TECHNICAL BULLETIN

23

Subject: Cascading Spray Dome
Applies to: See Below

Date: September 11, 2008
Rev. June 8, 2009

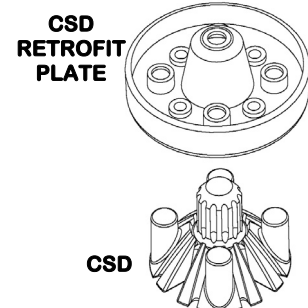
The following brewer models are now being manufactured with Cascading Spray Domes (CSD) instead of spray plates:

The CSD had previously been available only on the CBS-2021 Series and ECO Series brewers.

The CSD distributes water evenly over the coffee grounds and is a replacement for the spray plate used previously. The CSD is held in place by magnets, making it easier to remove and attach than the spray plate. It has no holes, making it easier to clean. It does not retain hot water above it, making it safer.

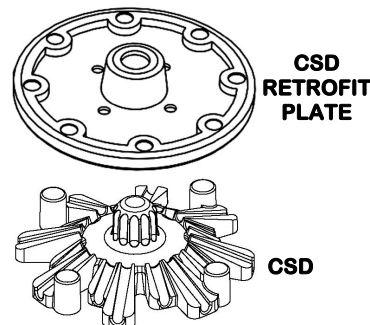
In addition to this production change, two CSD retrofit kits are available for modifying existing brewers with spray plates. The kits include the CSD, retrofit plate, sticker, screws, and instructions.

Part # K079 CSD retrofit kit, small

Part # K080 CSD retrofit kit, large

FETCO recommends that a qualified service technician install the CSD retrofit kit. After installation, brew test batches to verify proper brew levels. If necessary, adjust the brew valve flow rate as described in the brewer's Programming Instructions – Address 60/61.
